WELL API NO. 30-025-37676
5. Indicate Type of Lease STATE <input checked="" type="checkbox"/> FEE <input type="checkbox"/>
6. State Oil & Gas Lease No. VO-7528
7. Lease Name or Unit Agreement Name State 31
8. Well Number #1
9. OGRID Number 113315
10. Pool name or Wildcat Garrett Drinkard

**SUNDRY NOTICES AND REPORTS ON WELLS**  
 (DO NOT USE THIS FORM FOR PROPOSALS TO DRILL OR TO DEEPEN OR PLUG BACK TO A DIFFERENT RESERVOIR. USE "APPLICATION FOR PERMIT" (FORM C-101) FOR SUCH PROPOSALS.)

Texland Petroleum-Hobbs proposes to plug and abandon as follows:

**STATE 31 #1**  
Present Wellbore Schematic

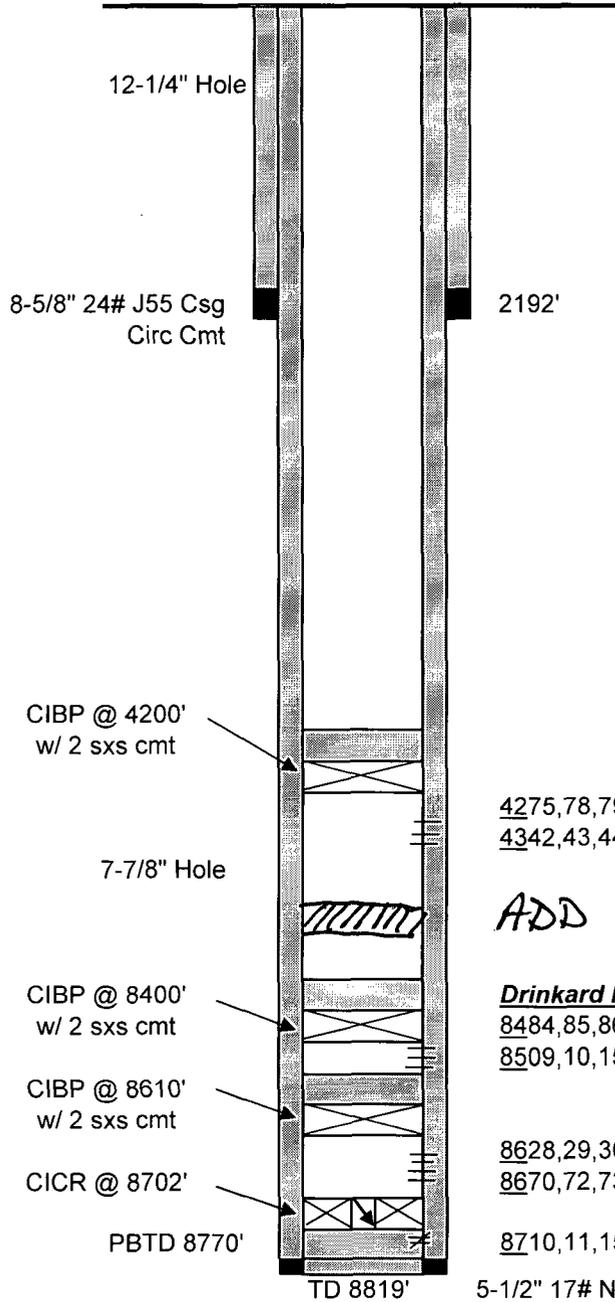
*ADD 25 sxs cmt @ 6659'*

- DRILL OUT CMT & CIBP @ 4200'.  
 - SPOT 25 SK PLUG @ 6659'. RE SET CIBP @ 4200'. CAP W/25 SKS CMT.

**STATE 31 #1**  
*Proposed P&A Schematic*

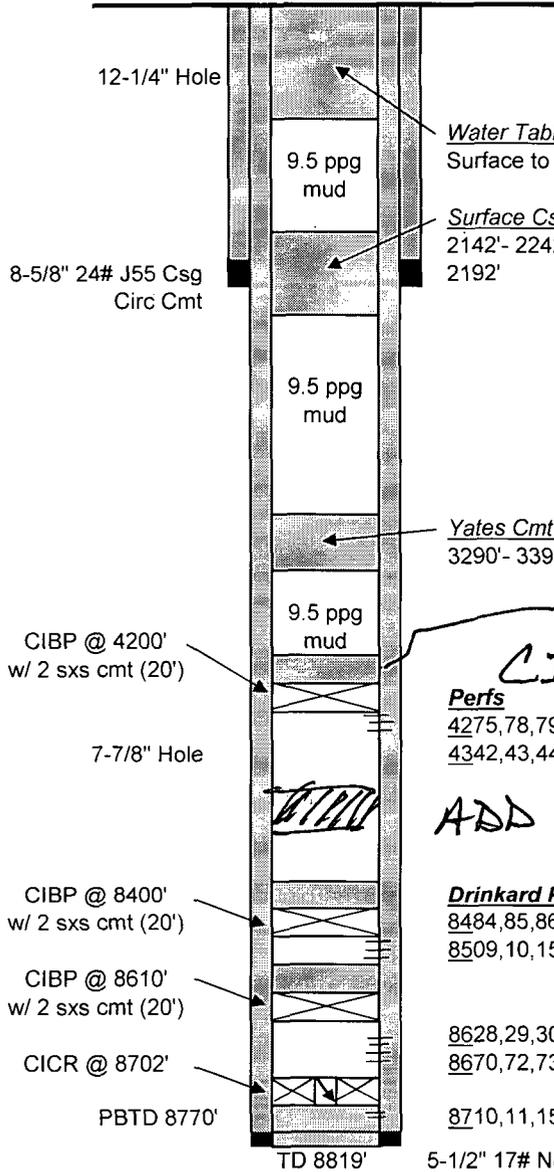
*CAP w/ 25 sxs CMT.  
 CIBP @ 4200*

*ADD 25 SXS CMT @ 6659'*
